寄件者:
寄件日期: 2025年07月10日星期四 16:16
收件者: tpbpd/PLAND
副本:
主旨: Fw: (Update 1) Departmental comments on YL-KTN/1119
附件: AYL-KTN 1119 20250709.pdf

有關漁農自然護理署對 A/YL-KTN/1119 的查詢

Proposed Temporary Open Storage
and associated Filling of Land for a Period of 3 Years

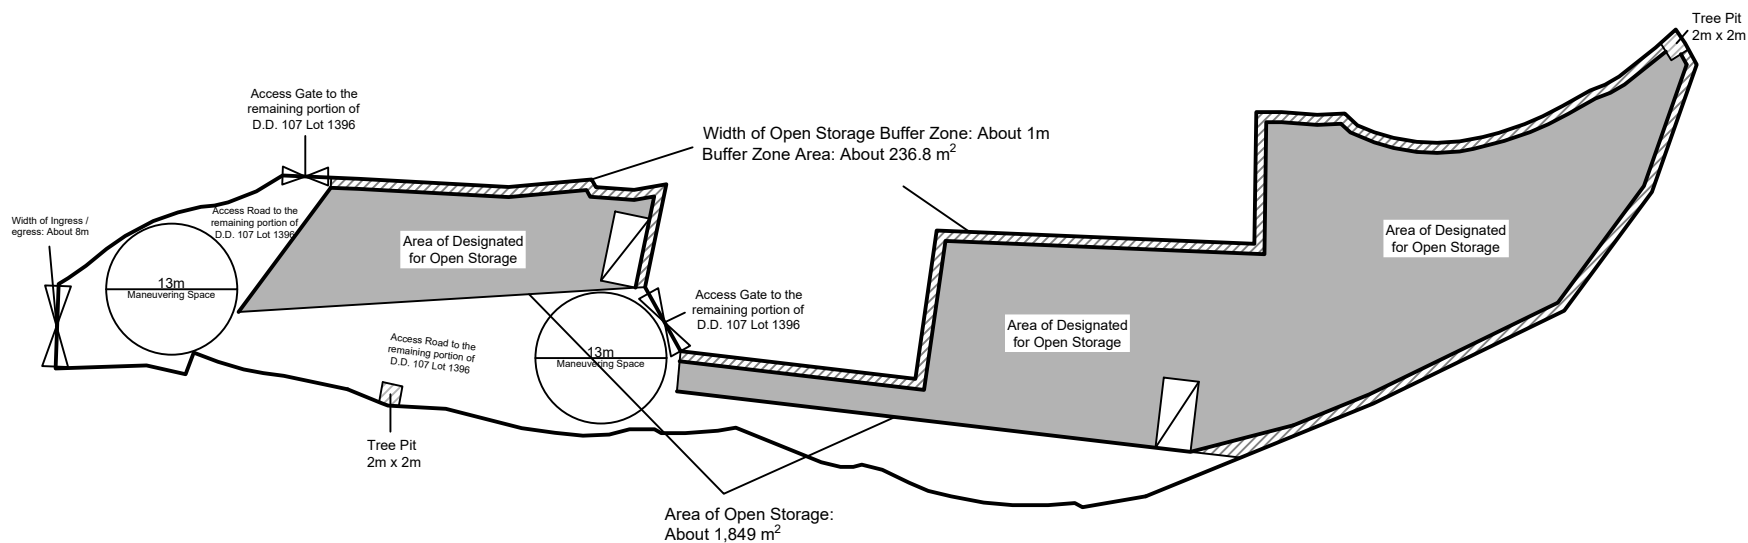
有關城市規劃委員會對 A/YL-KTN/1119 的查詢

在規劃獲批後會使用約 2.5 米高的金屬實心板將整個申請範圍圍起。

Drawing No.:
2-01

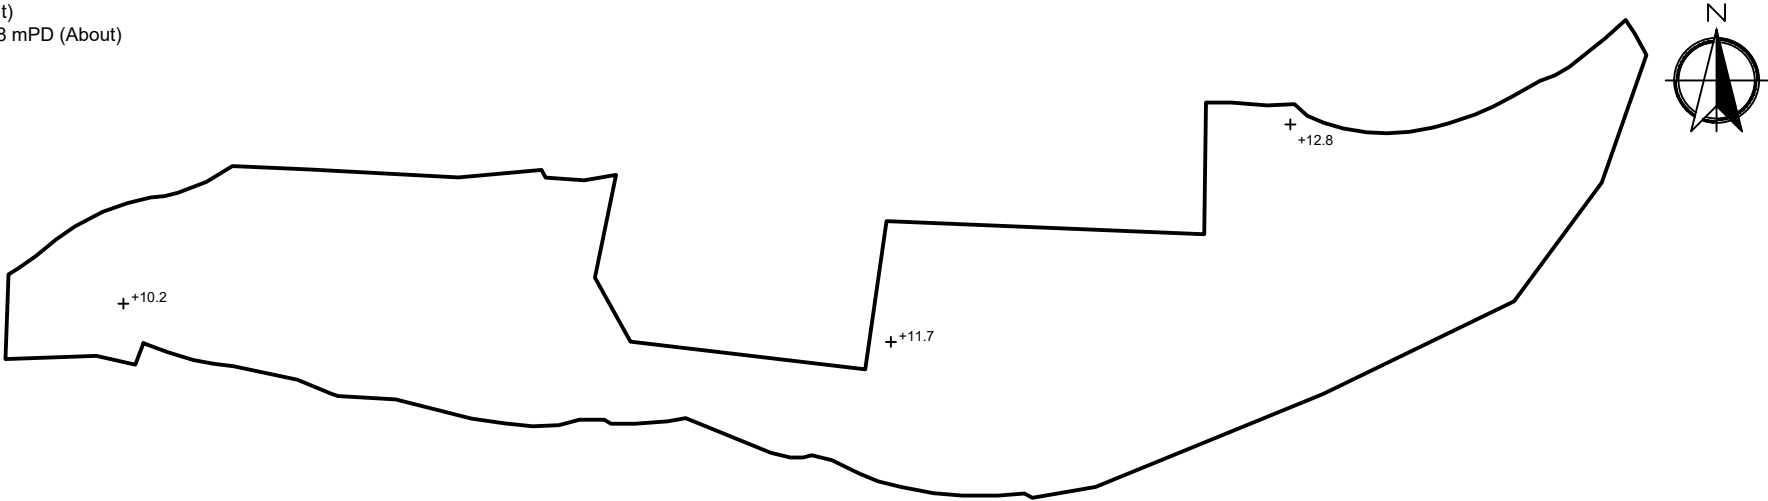
有關園境組對 A/YL-KTN/1119 的查詢

申請範圍內會種植兩棵竹柏，並會在樹幹 2 米範圍設有 2 米乘 2 米的保護區，保護區不會放置任何物品，以免影響樹木生長。樹木會定期檢查及修剪，保護樹木。種植範圍請參考 Appendix 2 及 Appendix 7。
